MEMORANDUM

FILE NO.: VAR2012 0024

PROPOSAL: Variance to allow a common driveway rather than an interior access street for a new two-lot subdivision on an arterial highway.

I HEREBY CERTIFY THIS IS A TRUE AND CORRECT PLAT OF
TRACT 2, WADLEIGH ROAD

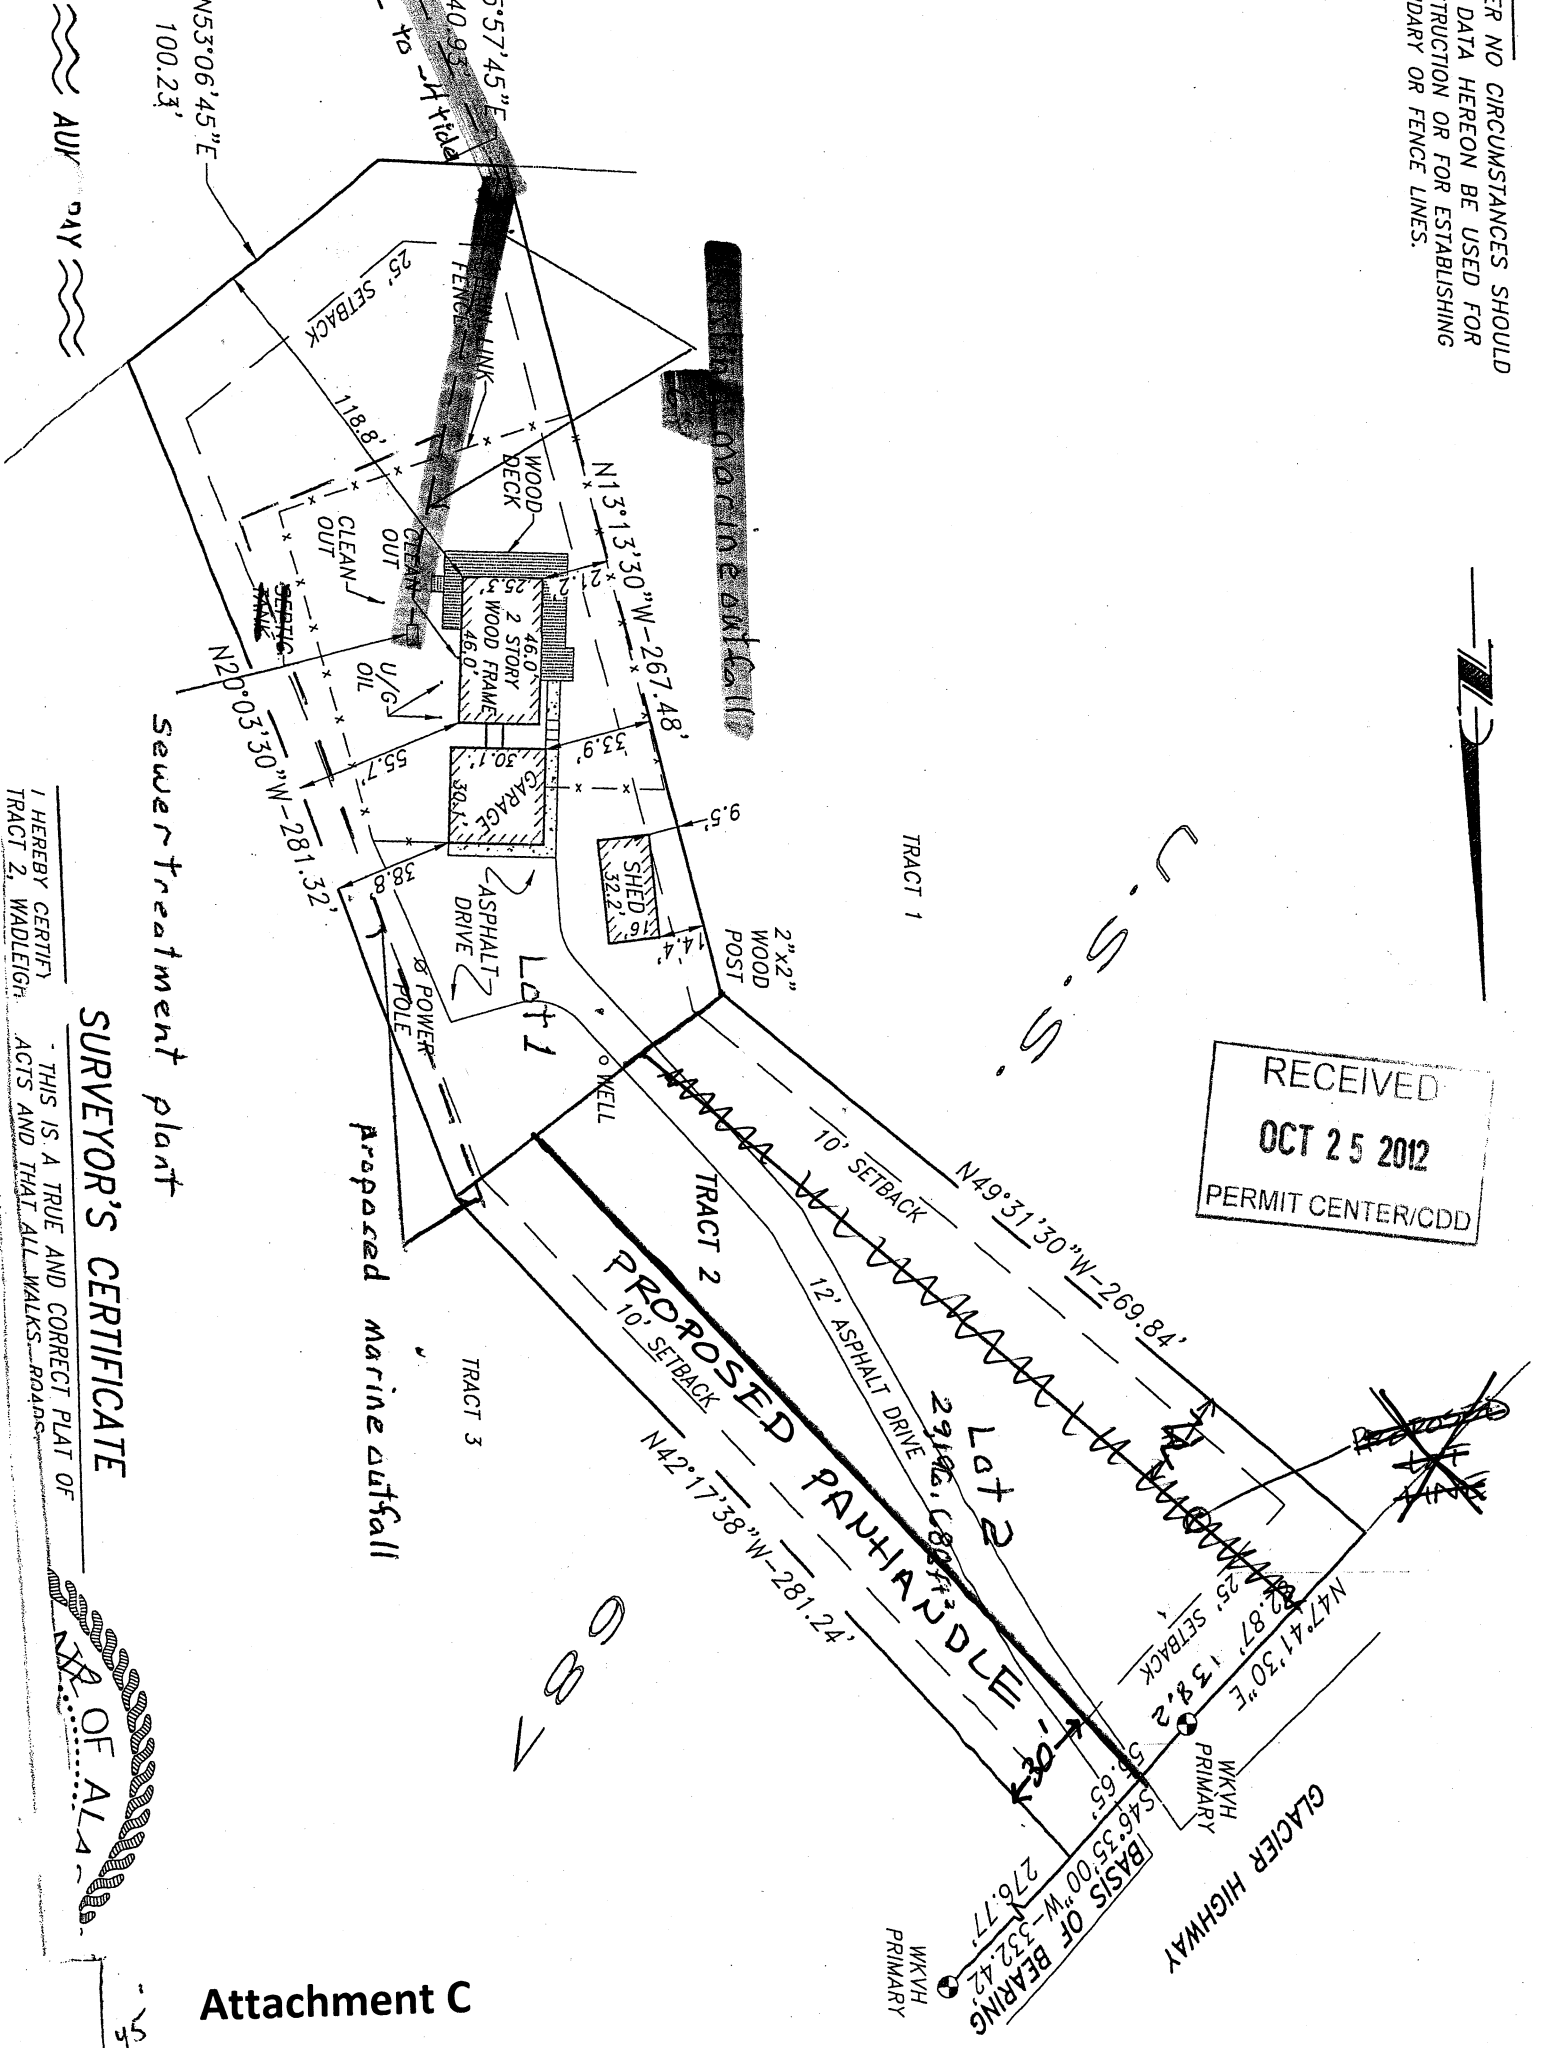
“DOT considers the existing driveway the preferred access to Glacier Highway from these lots. We would request a plat note stating that no access from the 30’ wide common access easement be allowed. The proposed 30’ easement would

locate a potential driveway too close to the neighboring property to the south. The applicant might consider relocating the 30' easement to the opposite side of the lot that way retaining the current access to Glacier Highway within the easement."

Thank you for the opportunity to comment. DOT considers the existing driveway the preferred access to Glacier Highway from these lots. We would request a plat note stating that no access from the 30' wide common access easement be allowed. The proposed 30' easement would locate a potential driveway too close to the neighboring property to the south. The applicant might consider relocating the 30' easement to the opposite side of the lot that way retaining the current access to Glacier Highway within the easement.

Based on these comments, and the proposed conditions of approval, the applicant has decided to locate the panhandle of the proposed subdivision on the opposite side of the lot (west as opposed to east), so that it will encompass the existing access point and provide greater flexibility for future development of an interior access street, should this ever become necessary.
